HYDROLOGY E11/D9 SAGECREST SUBDIVISION

Re: Tract 18 (Sagecrest Subdivision) Drainage Report

RE: SAGECREST SUBDIVISION

I have reviewed the drainage report for the subject subdivision. It cannot be approved for the following reasons:

FIGURE I-A
1" = 500'
MONTANO
SITE
O-S-A-1
ROAD
DRIVE
VISTA
VALLE
CREST LINE OF RIDGE
COORS
Drainage R.O.W.
La Mariposa
Phase I of Unit I

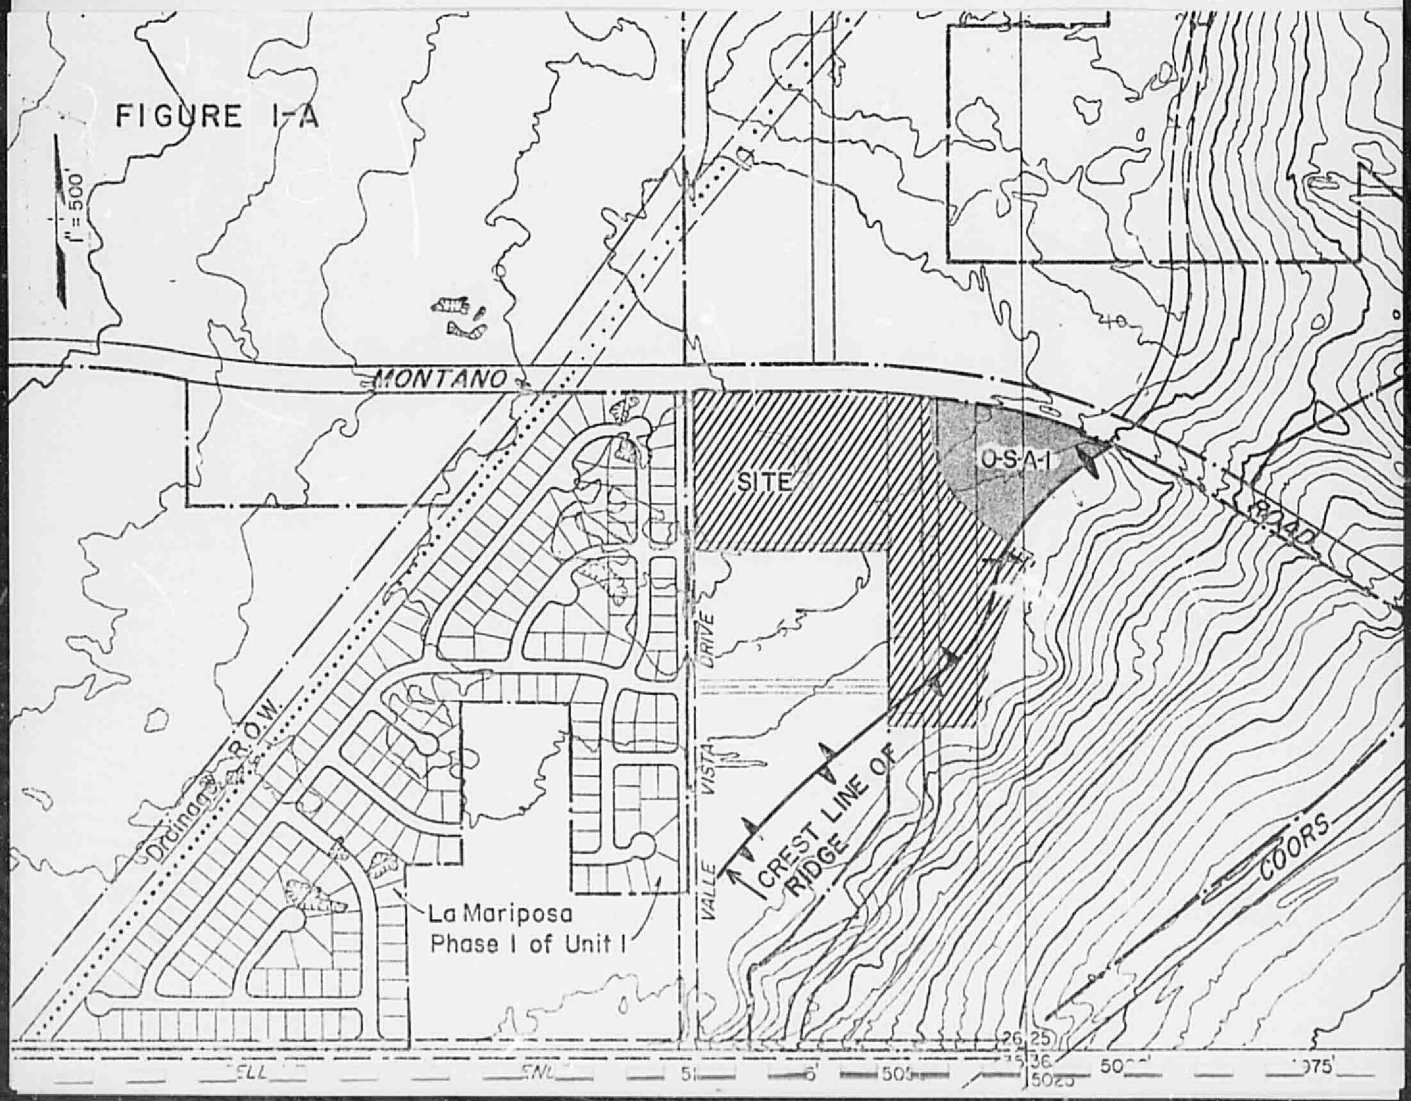
2. The flows from O-S-A-1 are diverted out of the natural ponding area, down Montano Road to the river valley which has no outlet. This clearly seems to violate the AMAFCA drainage resolution.
